**Evaluation of the Environmental and Social Impact Assessment (ESIA)
for the Oyu Tolgoi Copper and Gold Project**

Prepared by:

Environmental Law Alliance Worldwide U.S.

October 2012

Figure 5.22: Water Losses as a Percentage

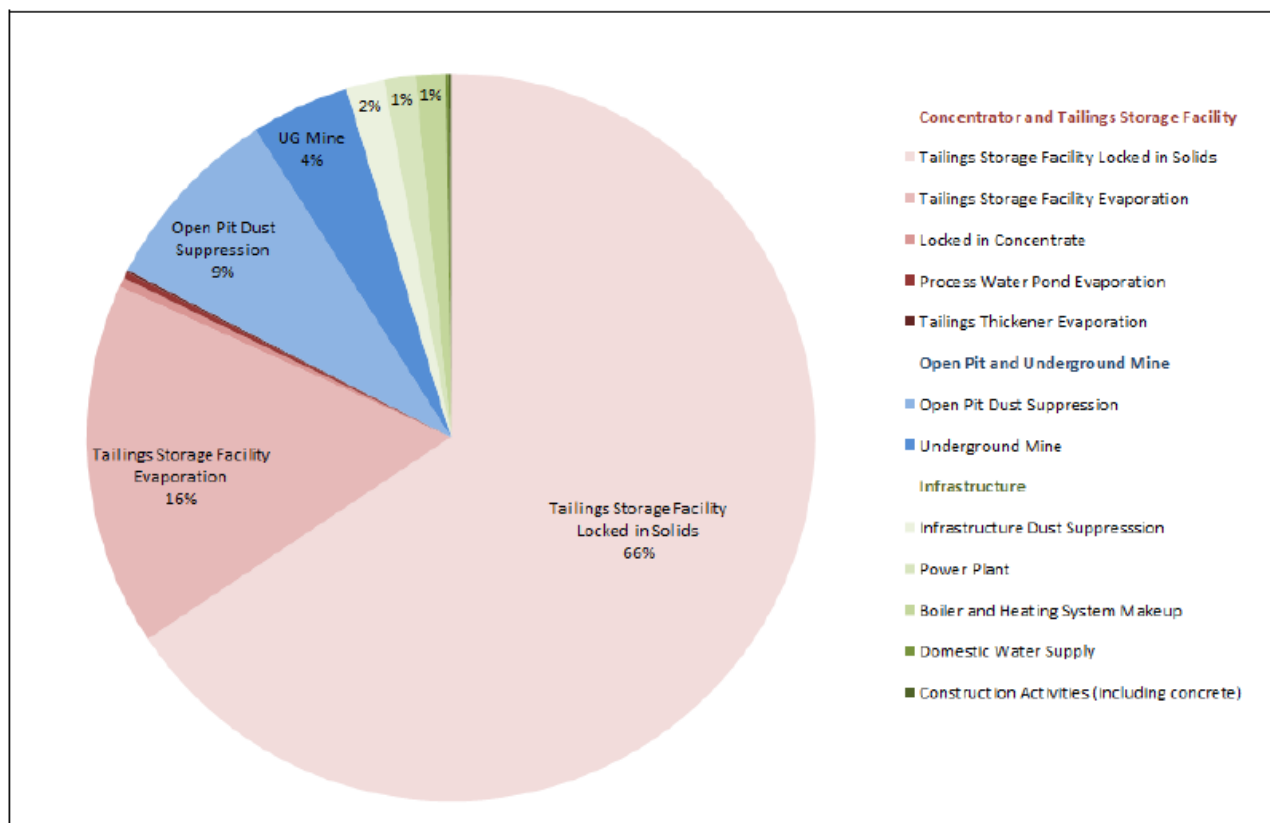
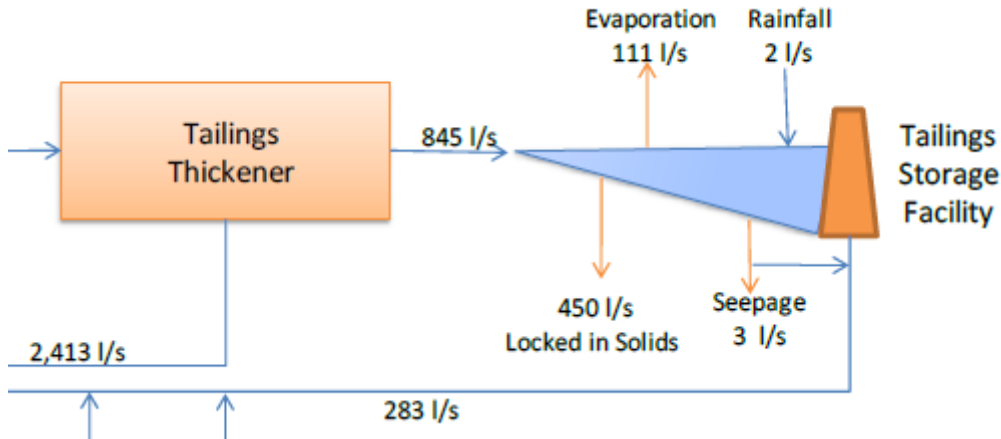
First, employing dry tailings disposal would greatly reduce the project's water demand. Figure 5.22 on page 55 of Chapter C5 of the ESIA shows that over 80% of the project's water losses will be associated with the choice of conventional tailings disposal and the associated tailings storage facility (see following page). Figure 5.23 of the ESIA on the following page of the ESIA shows that 450 liters per second would be locked into wet tailings and a further 111 liters per second would be lost from the wet tailings impoundment by evaporation.

What is so significant about these figures is that the combined losses from the tailings storage facility of 561 liters per second represents over 90% of the proposed groundwater abstraction for the project (620 liters per second). If water scarcity is a concern for this project, then the option of dry tailings disposal is an imperative.
